***Master Plan Amendment #2018-0008  
Text Amendment #2018-0014  
CDD Concept Plan #2018-0006  
Development Special Use Permit #2018-0002  
Potomac Yard Landbay H West - Silverstone  
2602 Main Line Boulevard***

Application	General Data	
<b>Project Name:</b> Potomac Yard Landbay H- West Silverstone	PC Hearing:	November 8, 2018
	CC Hearing:	November 17, 2018
	If approved, DSP Expiration:	November 17, 2021 (three years)
	Plan Acreage:	87,810 SF (2.01 acres)
<b>Location:</b> 2602 Main Line Boulevard (2600 & 2606 Main Line Boulevard)	Zone:	CDD #10 / Coordinated Development District #10
	Proposed Use:	Home for the Elderly (Assisted Living and Memory Care and Retail – Building 1; Independent Living – Building 2)
	Dwelling Units:	146 units (Building 2)
	Net Floor Area:	185,343 SF (Building 1) + 150,558 SF (Building 2) = 335,901 SF total
	Small Area Plan:	Potomac Yard/Potomac Greens
<b>Applicant:</b> Silverstone Alexandria, LP c/o Silverstone Senior Living represented by M. Catharine Puskar, attorney	Historic District:	Not applicable
	Green Building:	LEED Silver or equivalent
<b>Purpose of Application</b>		
The applicant requests approval of a Master Plan Amendment, initiation and approva

*Graphic A: Height-to-Setback Ratio Modification Exhibit*

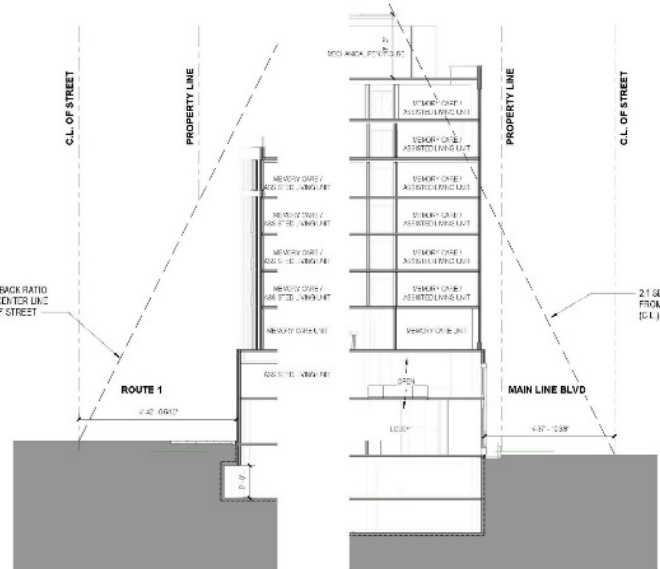
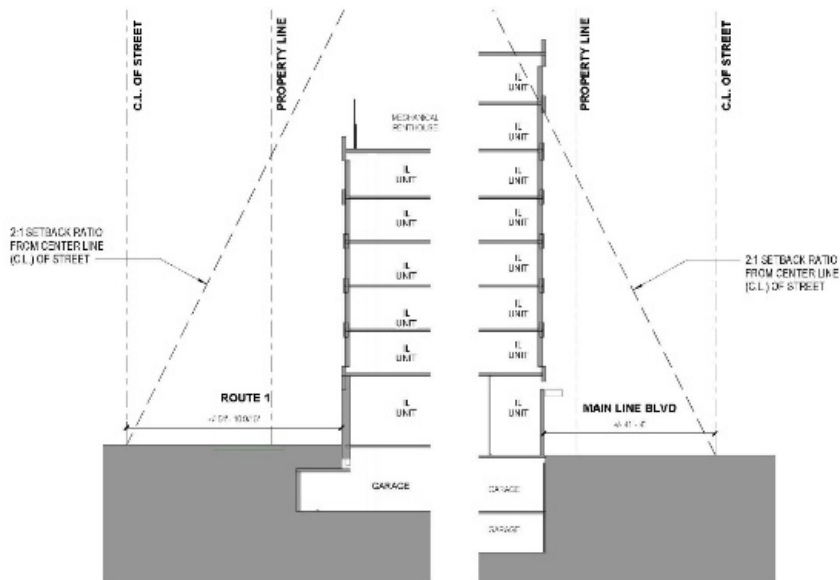
The height-to-setback requirement modification is requested in two instances for Building 1 (along Swann Avenue and Main Line Boulevard) and two instances for Building 2 (along Main Line Boulevard and Maskell Street). For Building 1, it represents about 16.5 feet of additional height compared to the setback provided along Swann Avenue and about 16.7 feet along Main Line Boulevard (or about 8.25 feet and 8.35 feet, respectively, of reduced setbacks compared to the heights provided).

For Building 2, it represents 13.2 feet of additional height compared to setback provided along Main Line Boulevard and 11.5 feet of additional height along Maskell Street (or about 6.6 feet and 5.75 feet, respectively, of reduced setbacks compared to the height provided). These types of modification are a result of the meandering nature and variable width of Main Line Boulevard coupled with the approved building heights per the Small Area Plan. The Small Area Plan anticipated taller buildings in this portion of Potomac Yard as blocks approached the Town Center in Landbay G and Landbay F (North Potomac Yard). Additionally, staff believes the modifications are desirable given that the proposed buildings are appropriately setback while supporting the continued streetwall consistent with the urban development pattern broadly recommended in the Small Area Plan and the Urban Design Guidelines and Standards. Both modifications have often been requested in other approval within Potomac Yard to create more urban buildings.

**Graphic B: Vision Clearance Modification Exhibit**

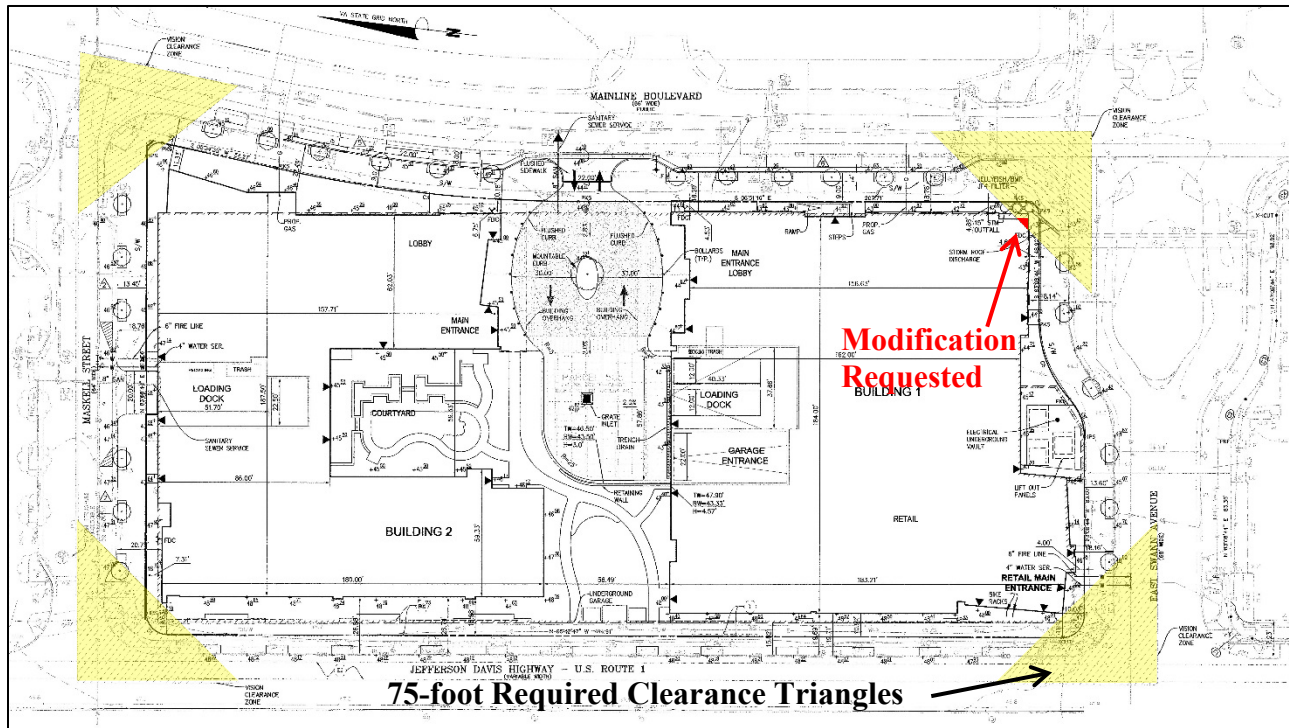
Both requested modifications are desirable in this instance. The modification of the vision clearance requirement is slight at only five feet less than required and would occur only at one of four intersections around the site (Main Line Boulevard and Swann Avenue).

improving the existing bump-out that provides reduced pedestrians crossing distance at the intersection for greater visibility and safety. This mitigates any minimal impact from the reduced vision clearance requirement. Regarding the height-to-setback requirement, the buildings have been designed in such a way that break down the form of the buildings using variable heights, building stepdown, and architectural detail. The buildings also comply with the streetscape standards per the Potomac Yard Design Guidelines as well as heights as proposed by the Small Area Plan. The adjacent vacant parcel in Landbay H is planned for office use with a maximum height of 110 feet and would be consistent with the heights proposed along Main Line Boulevard. Also, the ground-level open space and landscaping create a pleasant pedestrian environment that mitigate the requested height.

***Graphic F: Building #1 – Revised SW Elevation per PYDAC Comments 10.5.2018***

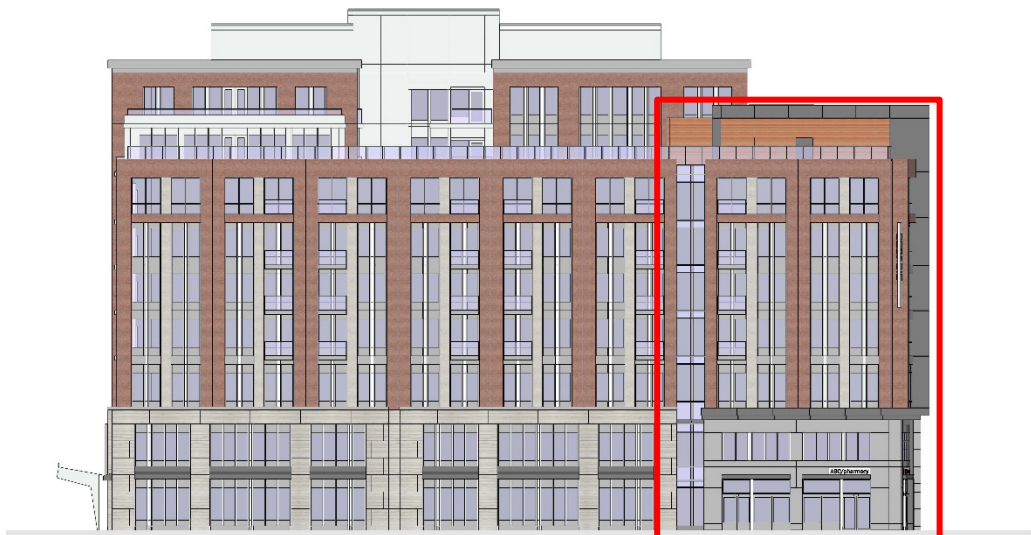
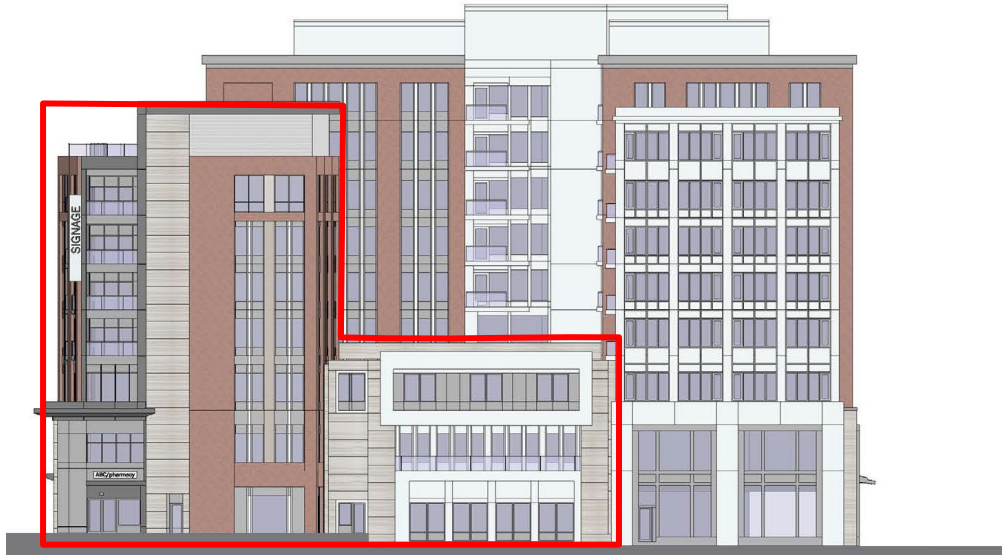
During their review at their June 27<sup>th</sup> meeting, PYDAC made a couple of design recommendations regarding the general direction of the building and side design. Following the June meeting, the applicant design team worked with staff to refine the building design, form, materiality and proportion and presented updated drawings at the September 19<sup>th</sup> meeting. During this meeting PYDAC conveyed overall support of the evolution of the building and site design however, requested the applicant continue to rethink the material selection of the building seam and revise the southern elevation and retail corner of Building 1. Additionally, PYDAC requested the applicant and staff provide contextual exhibits relative to the site. The applicant responded to the PYDAC design comments as shown in Graphic F & H, incorporating spandrel glazing at the building seam,

increasing the window proportion and material selection and the retail corner, and rethinking the material selection and design of the center massing on the southern elevation of Building 1. Additionally, the applicant provided a photomontage exhibit, as requested by PYDAC, to show the proposed buildings in context with the adjacent buildings to the north and south (Exhibit D).
